DESIGN KE	DRAWN BY JK	DART AEROSPACE LTD HAWKESBURY, ONTARIO, CANADA	
CHECKED H	APPROVED JK	DRAWING NO. DSI 9115	REV. A 1 OF 1
DATE 98.11.18	TITLE BAGGAGE DOOR LATCH KIT		SCALE NTS
A	98.11.18	NEW ISSUE

DART SERVICE INSTRUCTION

AMEND INSTALLATION DRAWING D350-588 REV. B AND D350-589 REV. B
STA: SH92-41
STC: SH1012NE

SECTION C-C AND E-E OF D350-588 REV. B
SECTION D-D OF D350-589 REV. B
SECTION C-C OF D350-589 REV. B MIRRORED

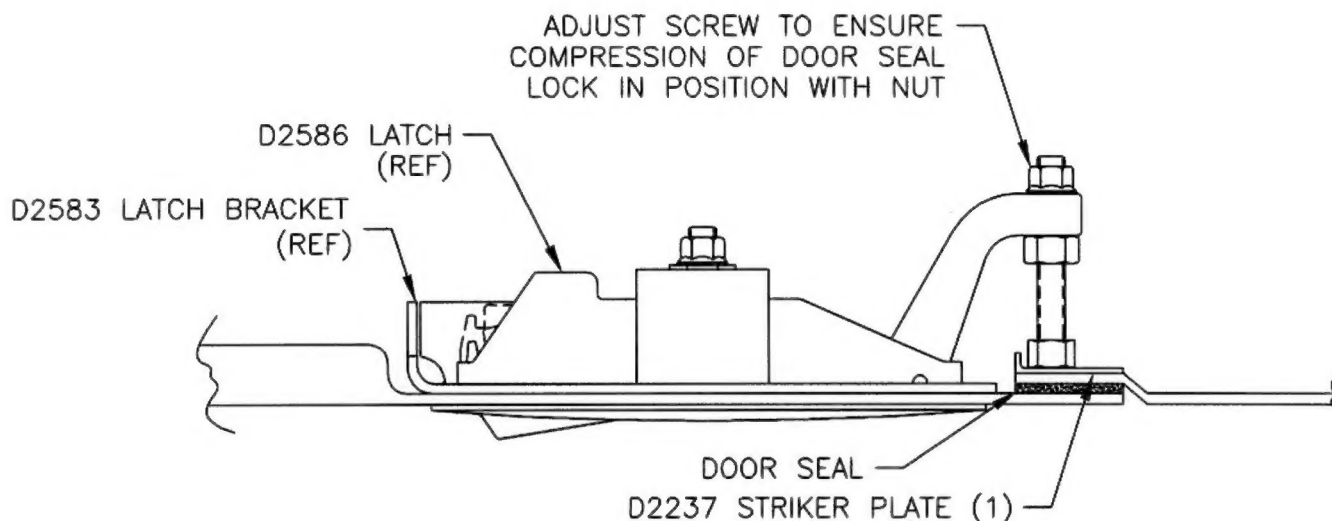
D2237 STRIKER PLATE & DOOR SEAL REVISED AS
ILLUSTRATED BELOW
